CNL-15-147

Watts Bar Nuclear Plant, Unit 1
Facility Operating License No. NFP-90
NRC Docket No. 50-390

Subject: **Responses to NRC Acceptance Review Questions for Watts Bar Nuclear Plant Unit 1 Essential Raw Cooling Water and Component Cooling System License Amendment Request (TAC No. MF6376)**

Responses to NRC Acceptance Review Questions Associated with WBN Unit 1 ERCW and CCS License Amendment Request

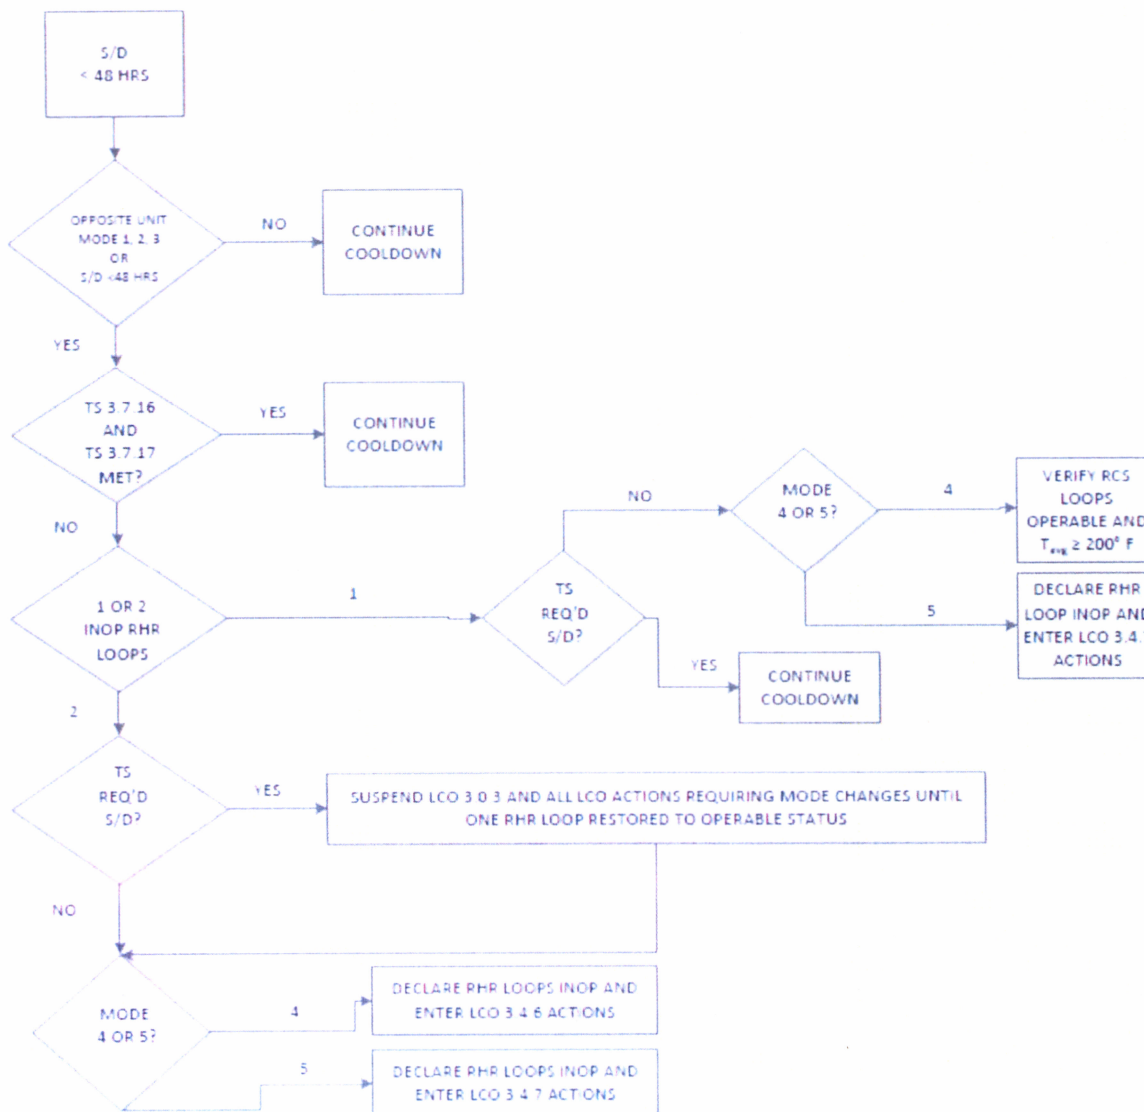
Provide information to justify and explain the inclusion of APPLICABILITY NOTE b in the proposed TSs 3.7.16 and 3.7.17. Also, clearly articulate the relationship of the proposed adoption of TSTF-273-A changes to the proposed CCS and ERCW TSs. All known scenarios similar to that of TS 3.8.1 discussed above should be identified and discussed.

The Applicability statements of TS 3.7.16 and TS 3.7.17, as submitted in Reference 1, have been revised by removing the exception of "When complying with Required Actions to be in MODE 5." In order to help determine the Required Actions to address the differences in the requirements relative to a TS-required shutdown and operation in Mode 4 or 5, the decision tree below was developed.

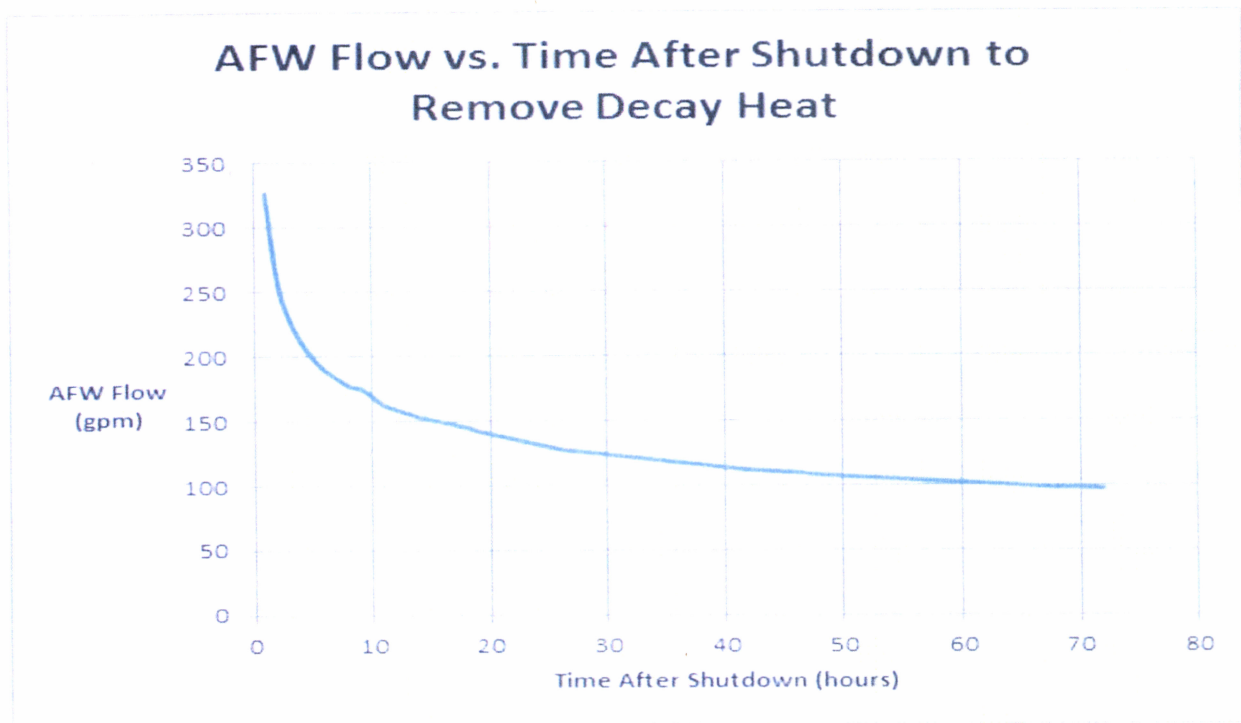
The licensee stated that Unit 1 could be maintained in Mode 3 or Mode 4 with decay heat being removed through the steam generators for at least 48 hours as one of the options for managing a unit shutdown. Using the steam generators in some scenarios, including a loss of offsite power, would require operation of Auxiliary Feed Water (AFW) for up to 48 hours; however, the Condensate Storage Tank (CST) lacks sufficient inventory to support operation of AFW for 48 hours. Final Safety Analysis Report (FSAR) Section 9.2.6.1 states, "The ERCW system pool quality feedwater will be used during an extreme emergency when safety is the prime consideration and steam generator cleanliness is of secondary importance."

Address the use of available and approved clean water sources, ERCW, and the CST in accordance with the approved licensing basis. The submittal should address whether ERCW would be added to the non-accident unit's steam generators for events other than those described in FSAR 9.2.6.3. Also address a dual-unit shutdown and cooldown to Mode 5, for instance as required by LCO 3.0.3, and the available water sources that are credited for use, including reference to approved procedures that implement these water sources for steam generator cooldown methods.

maintained by the FLEX program if power cannot be provided to the DWST booster pumps. The two CSTs have a cross tie that when opened provides an additional approximately 330,000 gallons of clean water for the case of a LOCA on one unit and the other unit being shutdown.

The design basis requires 410 gpm of AFW flow to remove the decay and sensible heat from the RCS at the time of a reactor trip. The actual demand on AFW drops substantially in the first hours after the reactor trip, as shown in the figure below.
